ADDENDUM NO. 1

BUILDING PERIMETER SECURITY AT THE DAVID L. LAWRENCE CONVENTION CENTER

PRE-BID MEETING, NOVEMBER 18, 2020, 2:00 PM

1. QUESTIONS:

3
D-2
BASE BID ITEMS

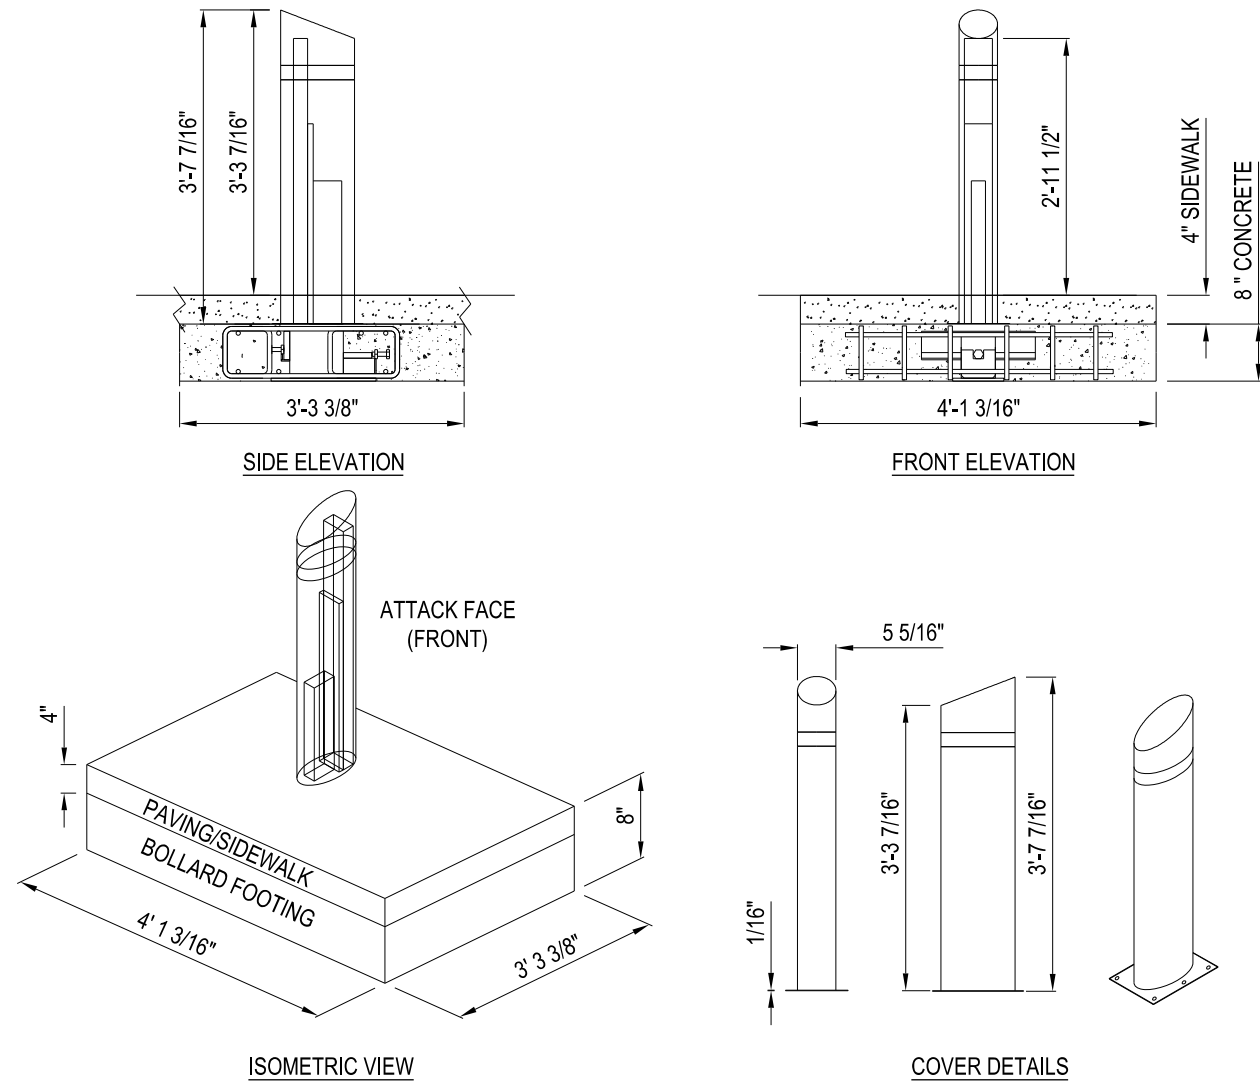
- q. How will the sidewalk concrete be cut and reinforced for installing the bollards?**
 - i. Size of the Bollard Foundation is defined by the manufacturer the contractor selects. The basis of design details are provided on drawing Sheet D-2 and indicates the specific re-enforcement requirements to support the anti-ram rating. Saw cut the coordinated and approved location of the bollard placement, remove depth as required by manufacture, install re-enforcement, and upright stoppers and pour concrete, finish and place cover over bollard.

- y. Drawing QY-4 shows 13 bollards and QY-5 shows 19 bollards for a total of 32 bollards. However, the table on Drawing D-2 notes a required quantity of 44 bollards. Please specify the intended location of the additional 12 bollards?**

- i. Please see QY-1 for overview of all locations
 - 1. (19) at East Lobby
 - 2. (6) at ADA ramps of East Side
 - 3. (13) at West Lobby
 - 4. (6) at ADA ramps of West Side

D-3

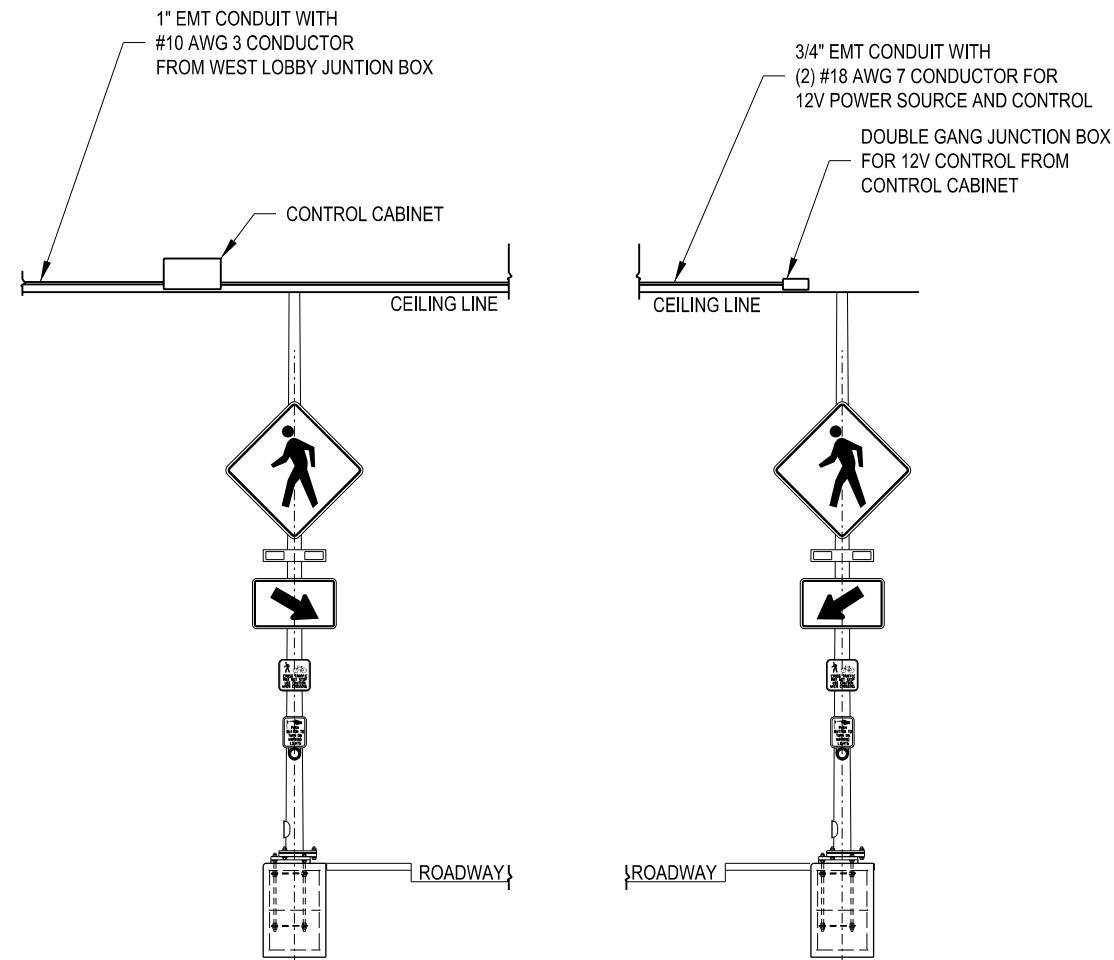
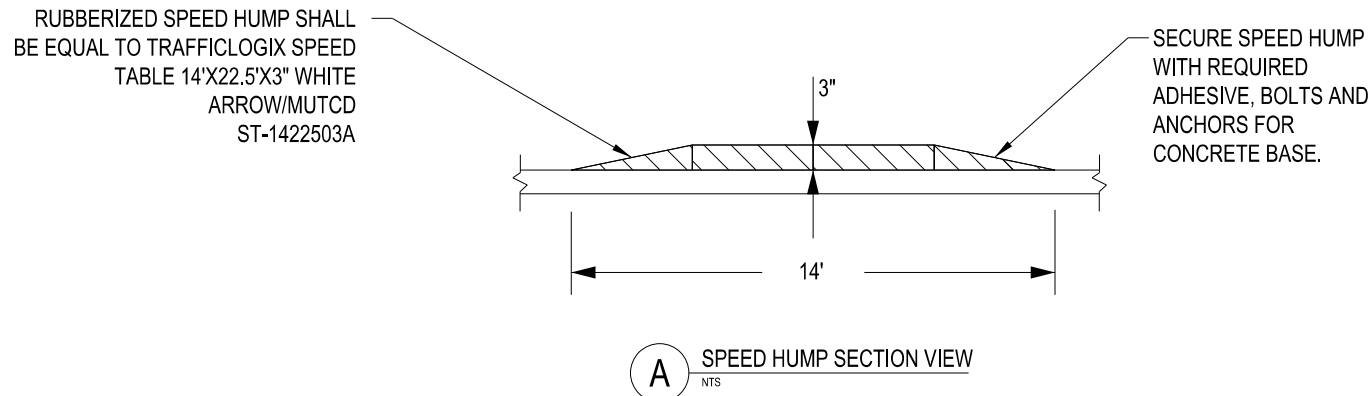
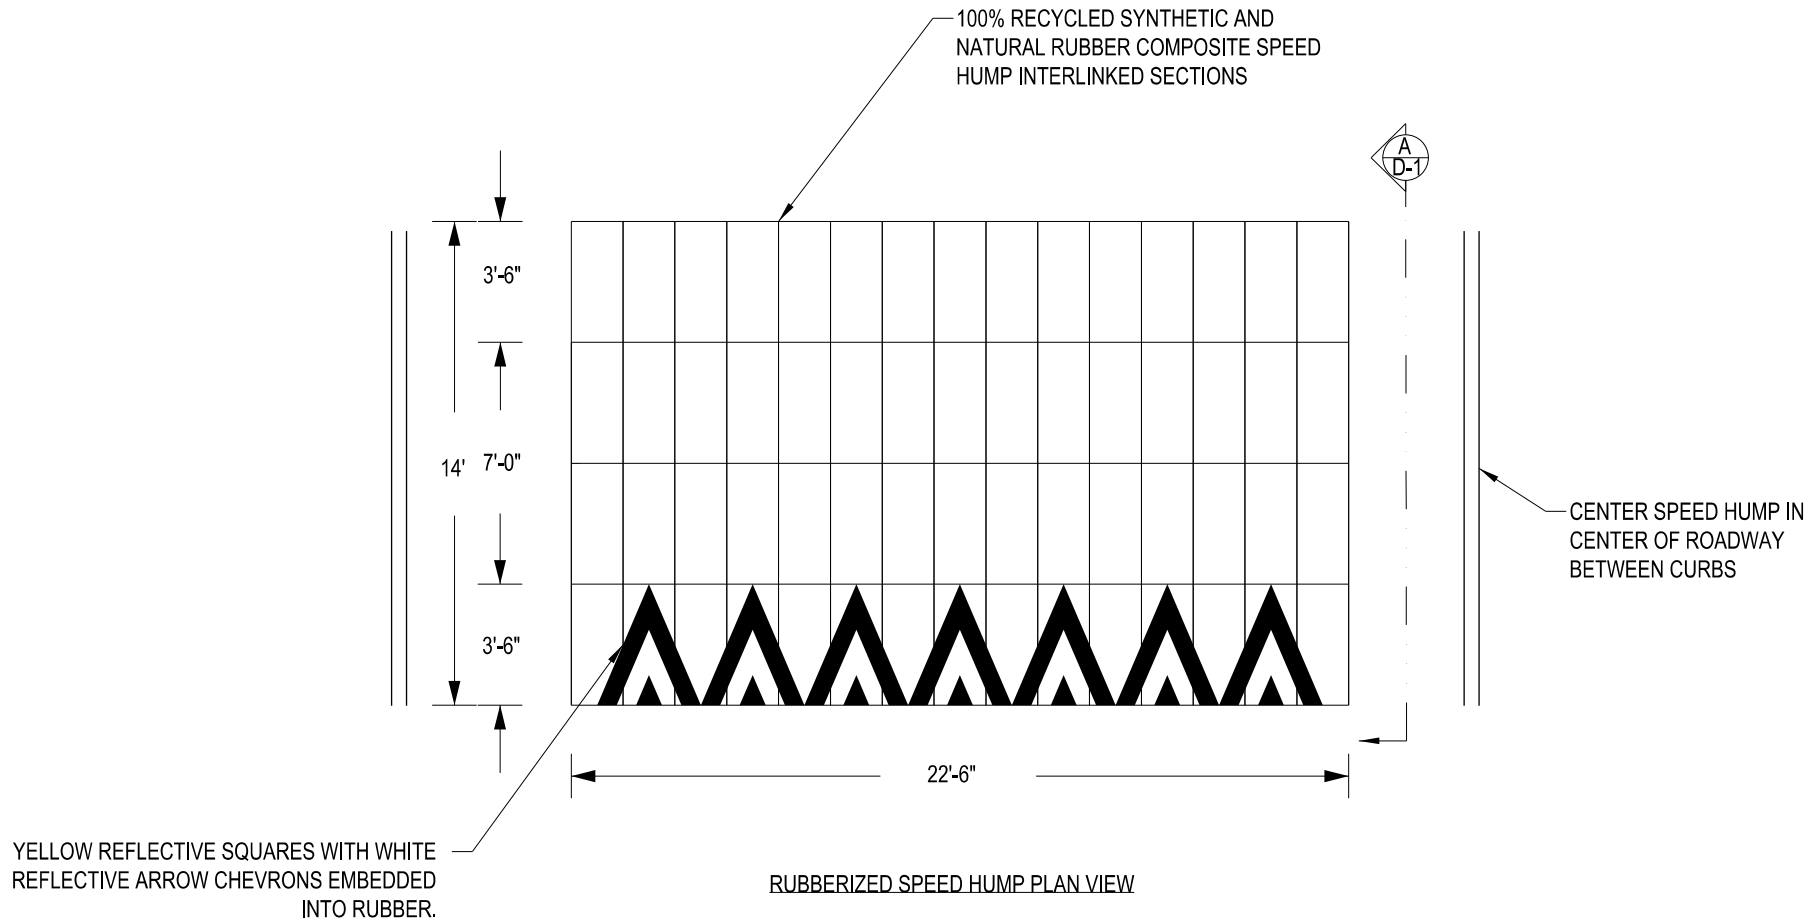
- k. How will the signal control wiring be run?**
 - i. See drawing sheet D-3 for details. (Please reference attached ROW Improvement Plan)
- l. Is the control box on the west lobby one wire and all self-contained?**

- m. What type of wiring will need to run west to east and back for traffic signal?**
 - i. See drawing Sheet D-3 for details, the exact product proposed by the bidder may require different cabling and must be coordinated if different than TranSystems Basis of design (or equal) product.

- x. What is the type of cabling required for the communications of the flashing rapid beacon system?**
 - i. See drawing sheet D-3 for installation requirements.

- i. See drawing Sheet D-3 for details, the exact product proposed by the bidder may require different cabling and must be coordinated if different than TranSystems Basis of design (or equal) product.
